STAFF RECOMMENDATION

C. Hart
NCPC File Nos. MP028 and
7019/7021/6918

**DISTRICT OF COLUMBIA VETERANS AFFAIRS MEDICAL CENTER CAMPUS
CAMPUS MASTER PLAN
4C WING EXPANSION, OPERATING ROOM/EMERGENCY
DEPARTMENT/DECONTAMINATION CENTER EXPANSION, FISHER HOUSE**

November 24, 2009

**Proposed Veterans Affairs Medical
Center Master Plan**

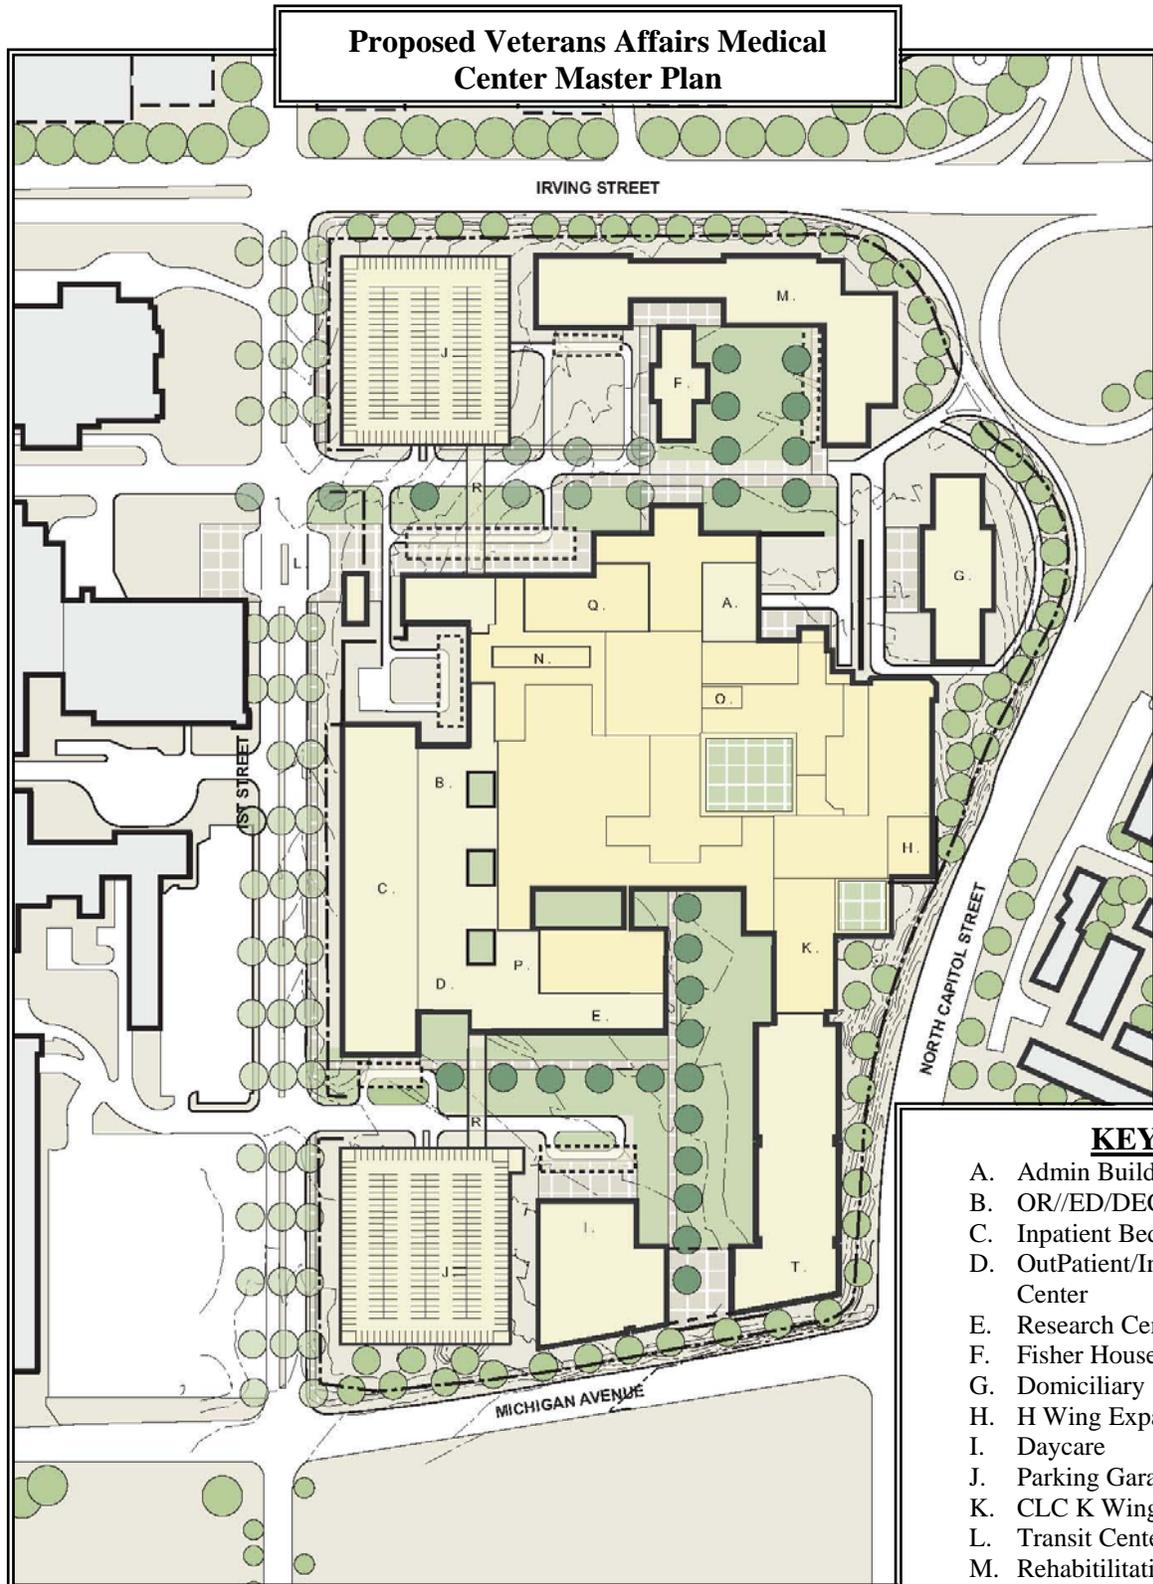
- Requires the applicant to modify the master plan to reflect recent planning work for the Armed Forces Retirement Home Master Plan and the North Capitol Street Cloverleaf Feasibility Study for active ground floor uses and build-to lines along Irving Street, NW.

- Requires the applicant to explore further the design of 1st Street, NW, as a pedestrian and bicycle connection for the VA Medical Center and between the Armed Forces Retirement Home site and the McMillan Sand Filtration site.

- Requires the applicant to provide more detail in the final master plan concerning the parking phasing to demonstrate that its parking ratio meets the 1:4 ratio stipulated in the Comprehensive Plan for the National Capital: Federal Elements as the master plan is realized and to submit additional justification for the increase in visitor parking.

- Requires the applicant to explore alternatives in the final master plan to address potential visual impacts of the Domiciliary and the Community Living Center on the North Capitol Street corridor and the Armed Forces Retirement Home viewshed. Alternatives for minimizing the impact include shifting these components, reducing their scale or adding landscape screening and need to be included in the final master plan.

- Requires the applicant to refine the perimeter security proposal in the final master plan to balance security needs and future planning objectives within an urban context.

PROPOSED CIRCULATION DIAGRAM

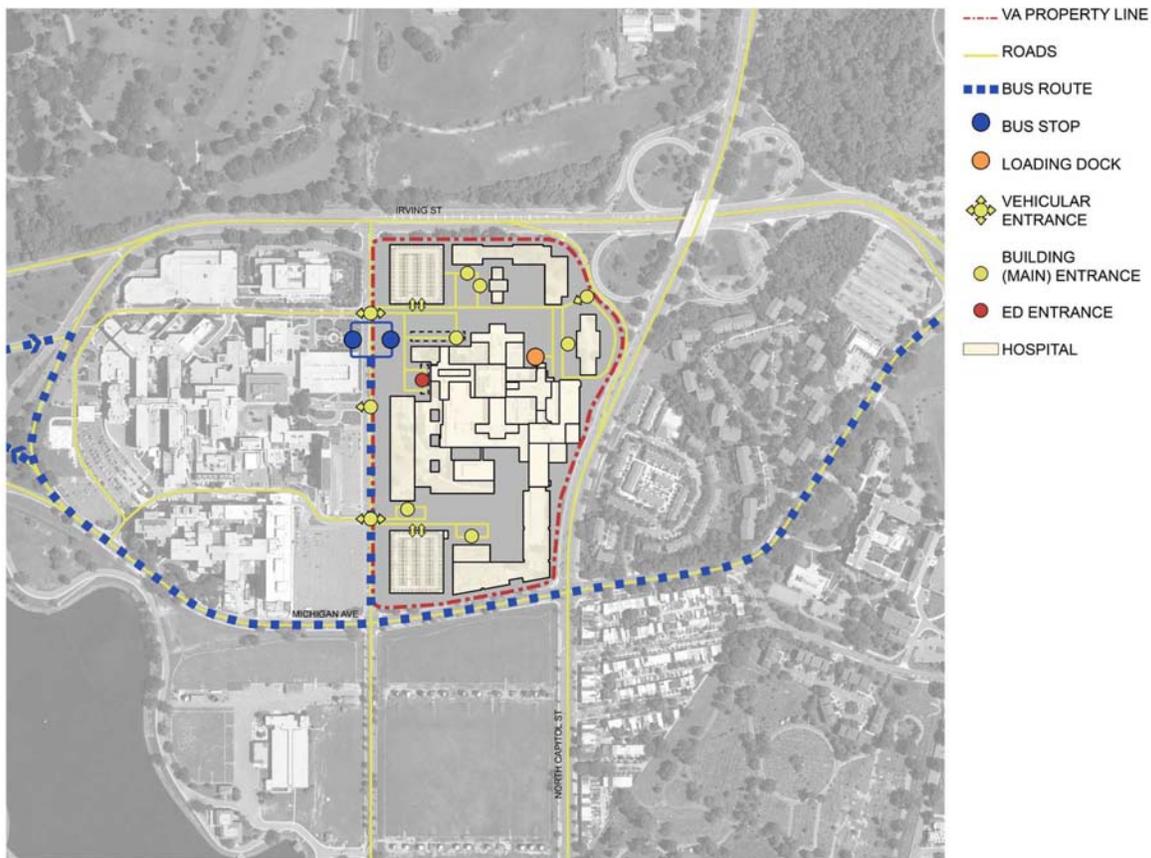
- Notes that the applicant should explore an agreement with DDOT and WMATA to better define the proposed transit center on the VA Medical Center campus. While this discussion has been initiated, it is not clear whether the transit center includes a reconfiguration of the roadway, rerouting buses, a pedestrian bridge over 1st Street, NW or some other option.

The master plan includes an option for treatment of the transit center and multiple options should be studied in the future and an agreement should be developed between the VA Medical Center, the Washington Hospital Center, the District Department of Transportation (DDOT) and Washington Metropolitan Area Transit Authority (WMATA). Variations in the bus turnaround such as creating a traffic circle at this intersection should be explored as well as the pedestrian overpass. In addition bus routes may need to be changed as well.
